1 RAPPORTAGE: NULINSPECTIE & EMC GAP-ANALYSE

Project: Simonshaven 380kV Uitbreiding (DP2-4)

DNV Reference: OPP-00436810-PSP 25-1757

Date: 15-1-2026

Photo reference IMG_6485

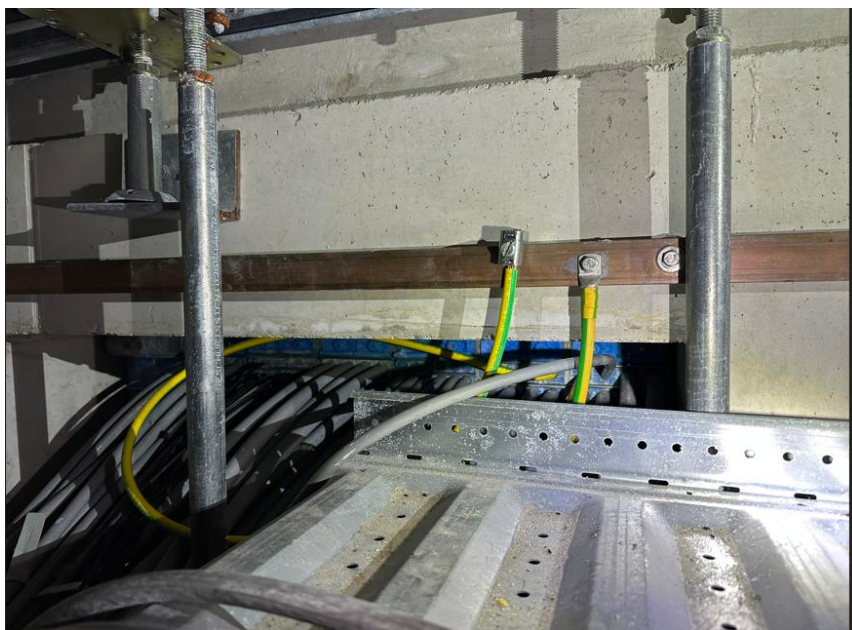
- **Inspection Scope:** Covers were not lifted but presence of a Parallel Earthing Conductor (PEC) was visible and terminated inside the Takhuisjes.
- **Observations:**
 - **Location 1 (Near CDG):** A copper PEC ($\geq 50\text{mm}^2$) was visible terminating inside. No External PEC was identified.
 - **Location 2 (Near Tak 1):** A copper PEC **Was** visible inside all Takhuisjes

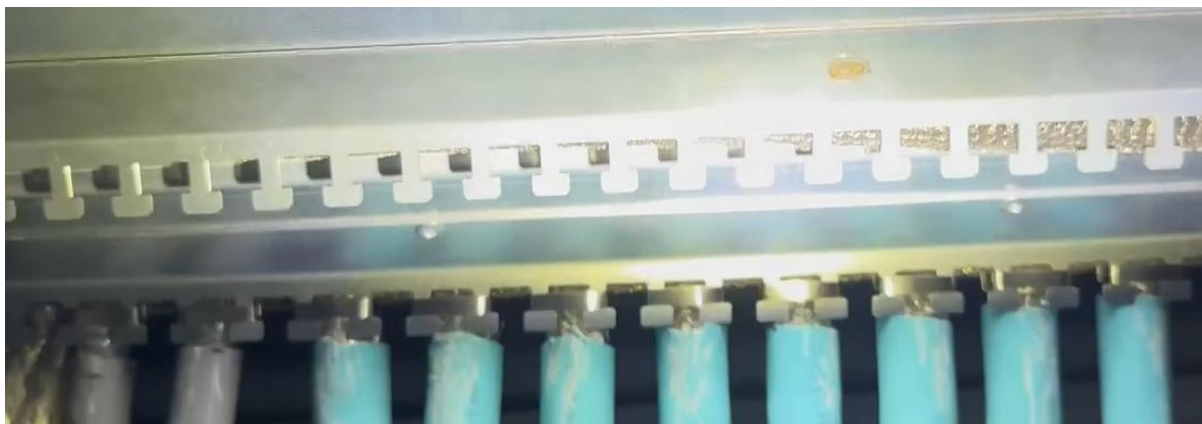
1. IMG_6466 (1 to 4 – Possible cables with shields passing through base plate without shields being bonded to base plate or via EMC glands).

2. IMG_6466 ((1) – Excess cable coiled – coiled cable with shield exposed to magnetic fields and passing through base plate without shield being bonded to plate or via EMC gland (2)).

3. IMG_6466 (Good example of cable shields being bonded to base plate).

4. IMG_6467 (Good example of cable shields being bonded to base plate).

5. IMG_6469 (1 – Possible cables with shields passing through base plate without shields being bonded to base plate via EMC glands).

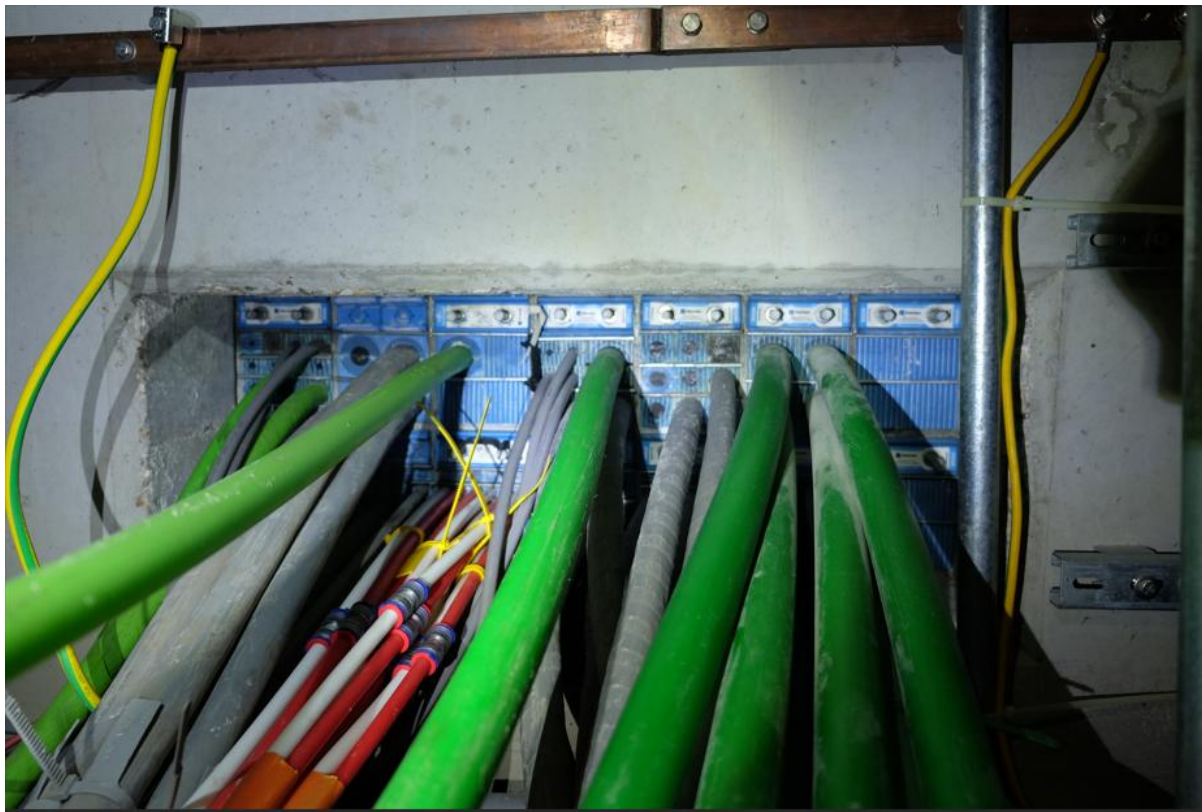
6. SMH002 (Is Roxtec metal frame bonded to earth – as discussed).

1. SMH045 (Example of corrosion – most likely caused by dissimilar metals).

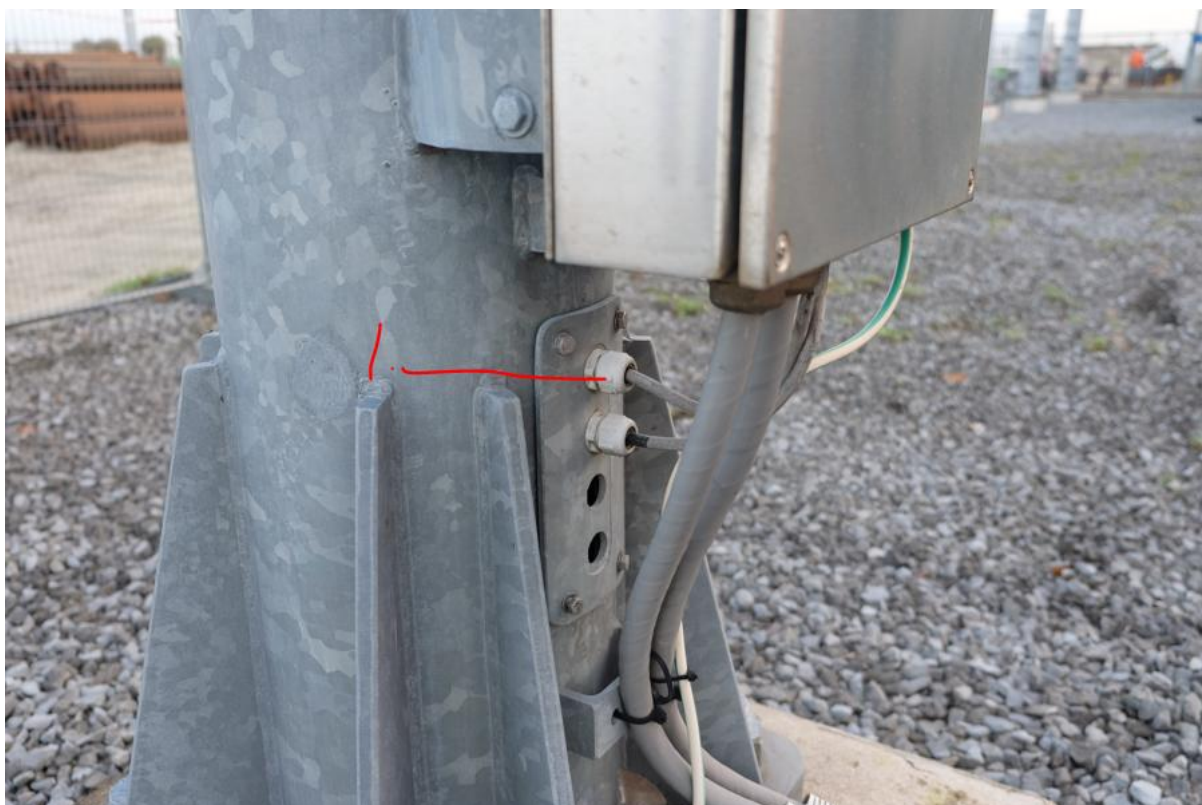
2. SMH051 (Appears to be plastic connectors that are not EMC compliant).

3. SMH056 (Poor electrical contact (lugs on paint and not metal)).

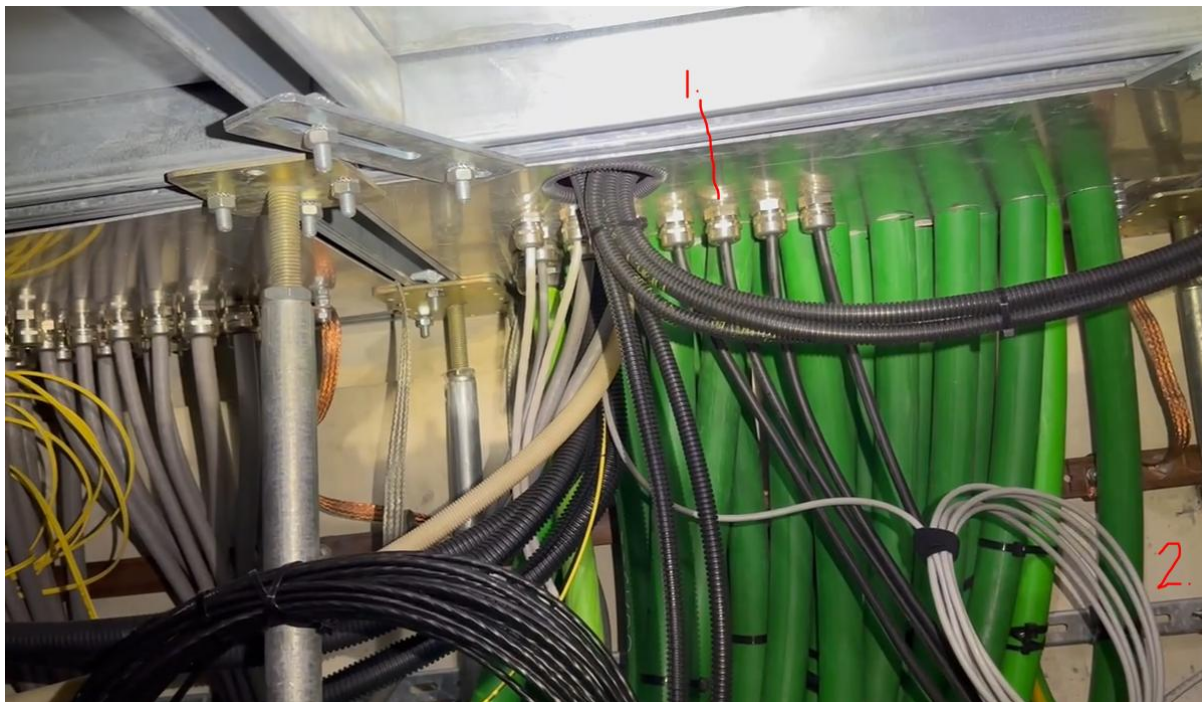
1. IMG_6491 (Appears to be plastic connectors that are not EMC compliant).

4. IMG_6492 (Good example of use of EMC connectors – bonding of cable shields to enclosure to be confirmed by measurement).

1. IMG_6470 ((1) – Possible cables with shields passing through base plate without shields being bonded to base plate or via EMC glands). (2) – Excess cable coiled – coiled cable with shield exposed to magnetic fields and passing through base plate without shield being bonded to plate or via EMC gland).

2. SMH042 (Appears to be plastic connectors that are not EMC compliant).

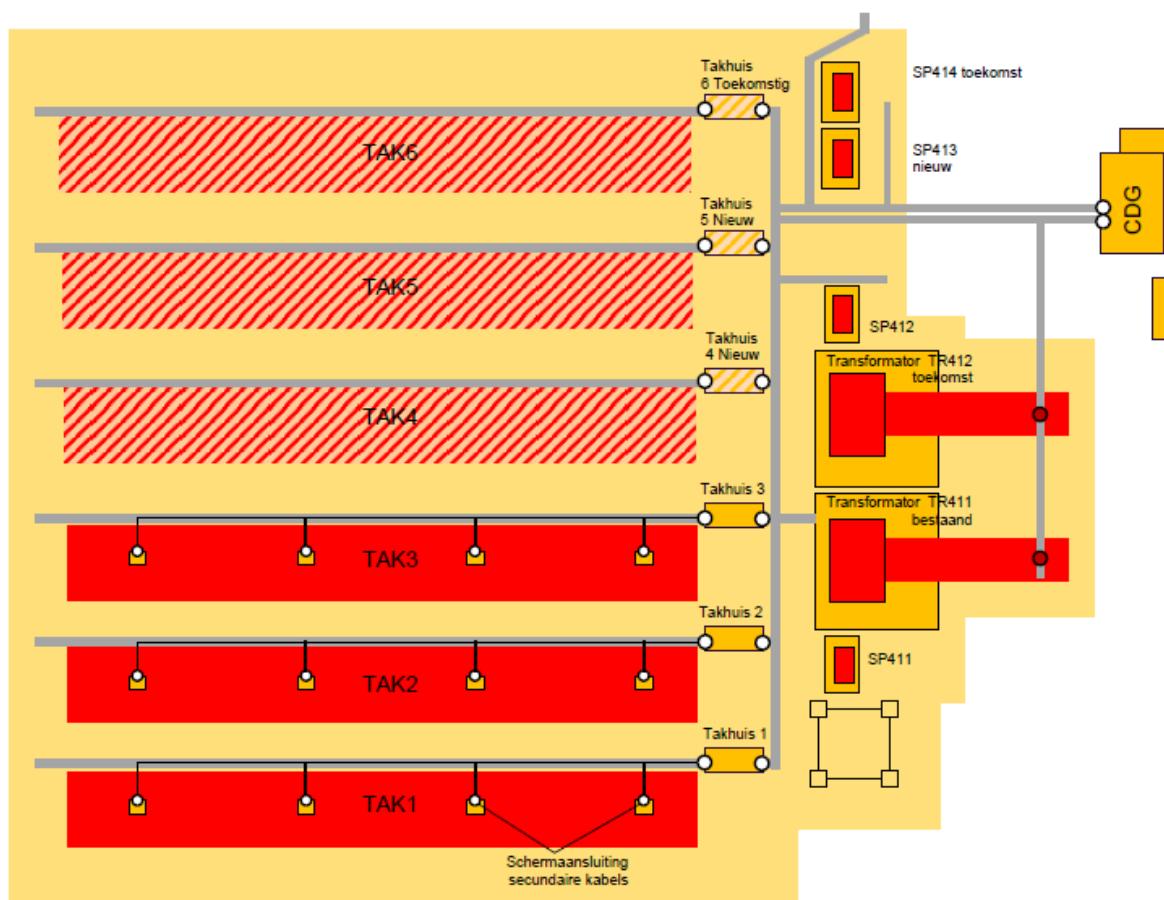
1. SMH064 ((1) and (2) appears to be plastic connectors that are not EMC compliant).
